Re: Façade Review at 8 Elm St., 348-350 Yonge St. (including 2-6 Elm St.), 352-354 Yonge St.

Further to your request to review the conservation report prepared by GBCA on November 8th, 2019, as well as to attend the site and conduct a field review; I am pleased to report my findings as follows:

Photo #1:
Roof signage strap
anchors

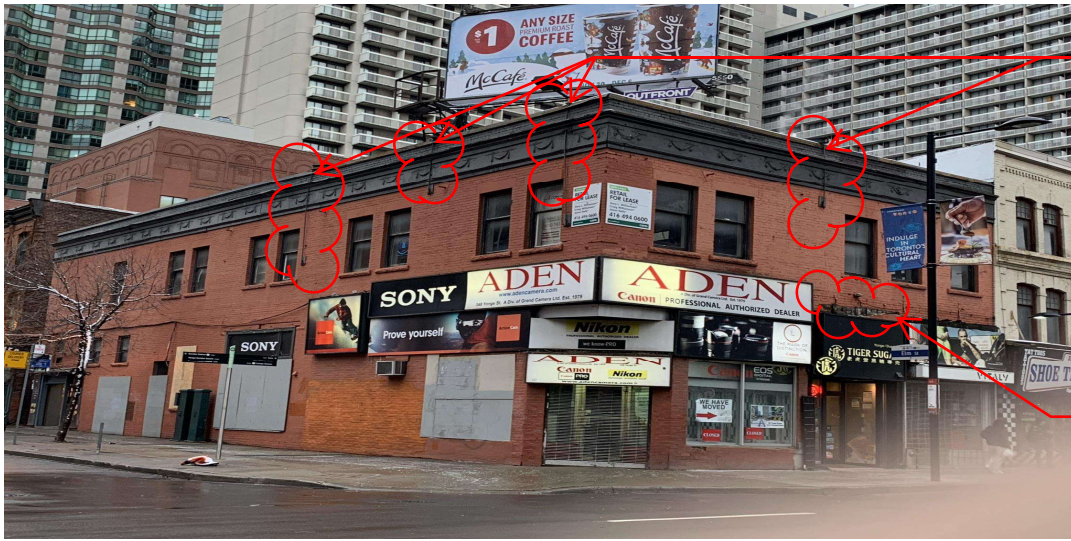
- Our review of the portion of the façade slated for retention in the Conservation Plan is in much poorer condition than observed in the 2019 report. The signage tie-down strap system (see photos 1&2) has created damage to the façade. This damage ranges from crushing the metal frieze profiles to excerpting large loads on the masonry load bearing walls. The traditional brick and lime mortar masonry walls were never intended nor designed for this application and as such this condition has caused movement and stress on the wall surfaces.

- The large number of open joints visible at the exposed sign-band level supports the speculation in the GBCA report that the main wood or steel support beam will most likely be in very poor condition when the wall assemblies are exposed.
- We noted on site the removal of the layers of signage, etc. to be undertaken by the heritage contractor, as portions or remnants of the original fabric may be encapsulated under the build-up

Upon the findings of the meeting, the parties agreed that the façade retention noted should be amended for a panelization approach. The panelization approach will ensure better quality and ease of repair, restoration, or replacement of the main support beam. This approach will allow for a concealed reinforcing of the original heritage fabric to rectify the damage caused by the tie-down roof signage anchors. This approach will also ensure that the corner façade, which is most at risk by crane activities during the new build, is removed from the site during construction activities and reinstated. This approach will reduce the risks associated with exposure of the back side (interior underfired brick) from the elements. I have included a proposed panelization sketch (see Photo #4).
